From: Bowman, Eric
Sent: Tuesday, December 08, 2015 1:32 PM
To: MAUER, Andrew
Cc: Shams, Mohamed; DiFrancesco, Nicholas; Chokshi, Nilesh; Jackson, Diane
Subject: RE: Appendix H
Attachments: Appendix H to NEI 12-06 December 8 clean - eeb comments.docx

My comments are attached as edits to the document in track changes rather than as comment bubbles for you to take action on. This reflects further staff input on the appendix subsequent to the comments Mo provided last week. I haven't provided specific comment on path 5 since it isn't mature yet or on the 1.4xSSE special case we discussed earlier.

NEI 12-06 APPENDIX H

Figure H.2: Mitigating Strategies Assessment Process for the MSSHI

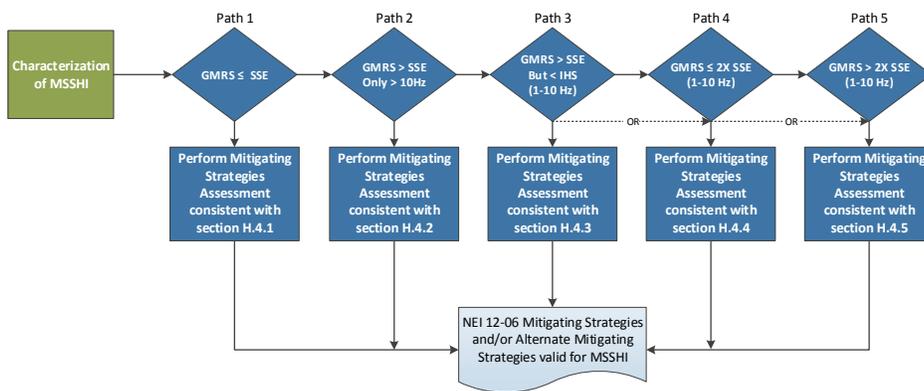
Commented [BE3]: I'm not sure if my earlier comment on this was passed along, but as you have it written the direction to use figure H.2 Path 2 would have the reader go to that figure and read the process block that says to do the MSA consistent with section H.4.2., which is this section. I believe that is doing the reader a disservice because there is no value added and it makes someone flip back and forth through the pages. I would correct this as I've proposed here by eliminating the reference to figure H.2; it has served its purpose in illustrating the process in section H.3 and should not need to be referred back to in the subsections of H.4 for anything.
